IEC 61076-2-101
(Second edition – 2008)

Connectors for electronic equipment – Product requirements –
Part 2-101: Circular connectors – Detail specification for M12 connectors with screw-locking

CORRIGENDUM 1

Figure 21 – Pin front view A-coding

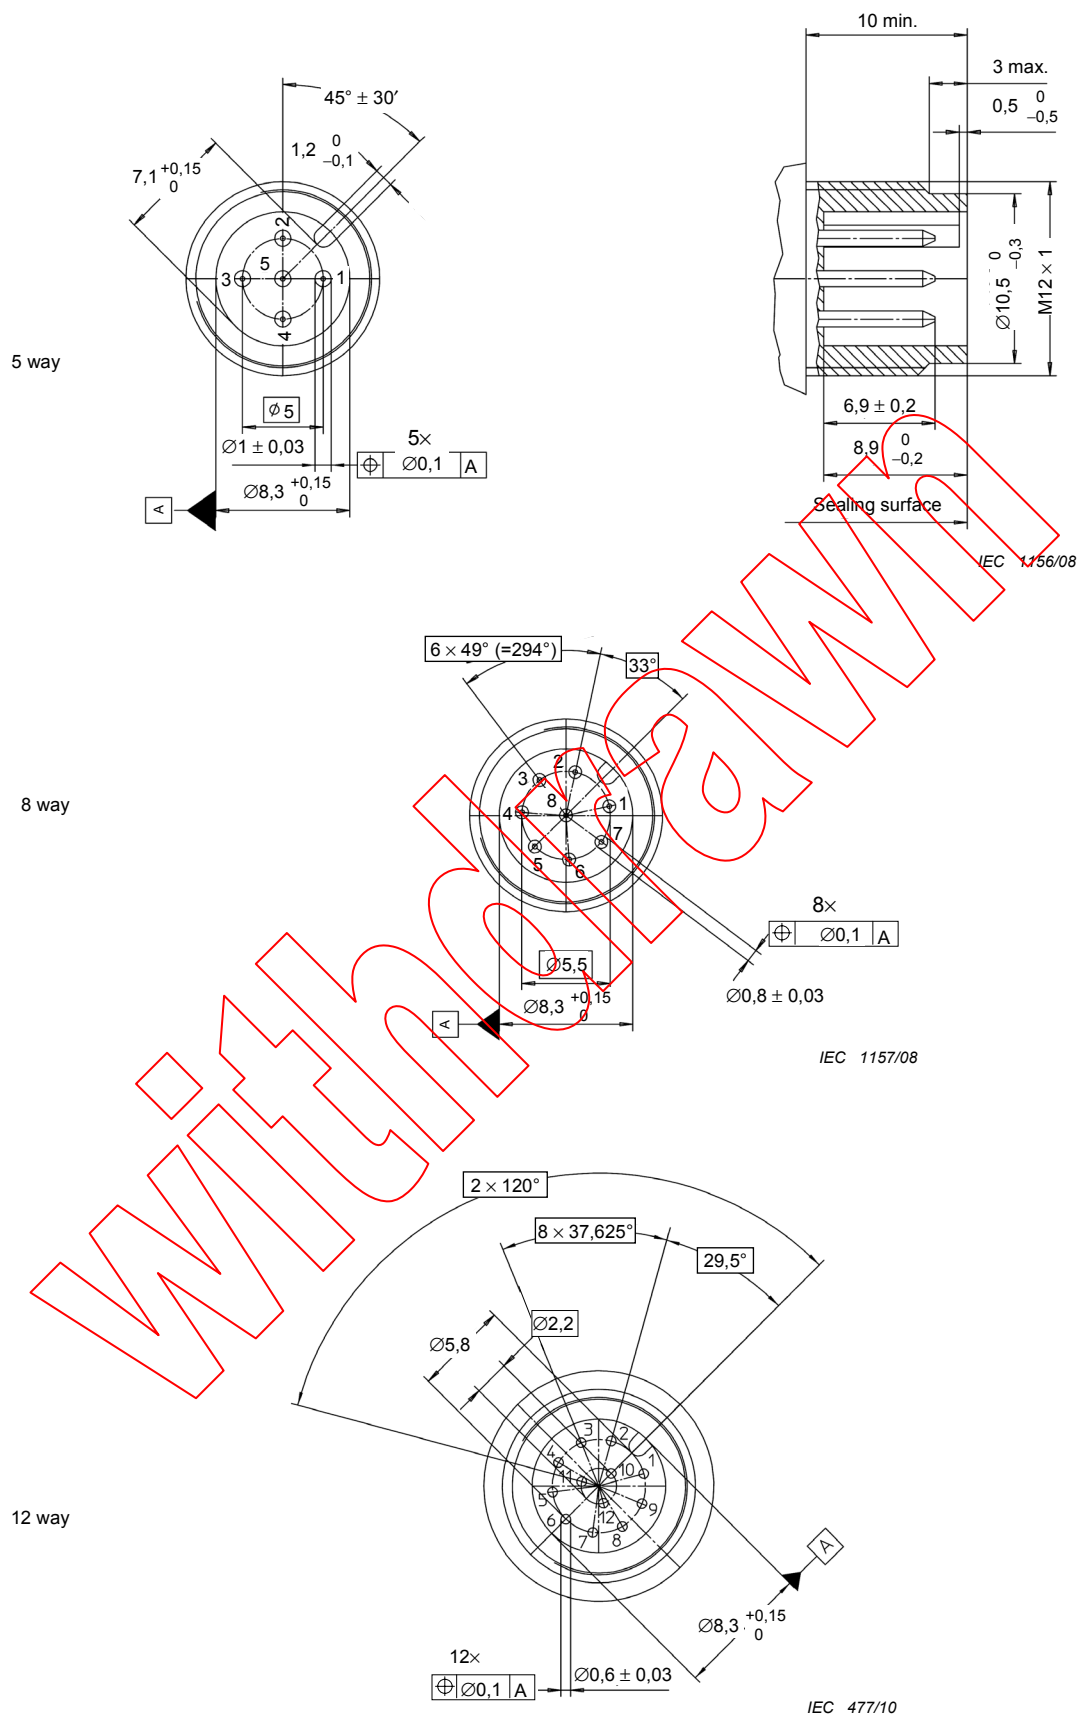
*Replace existing **Figure 21 – Pin front view A-coding** by the following:*
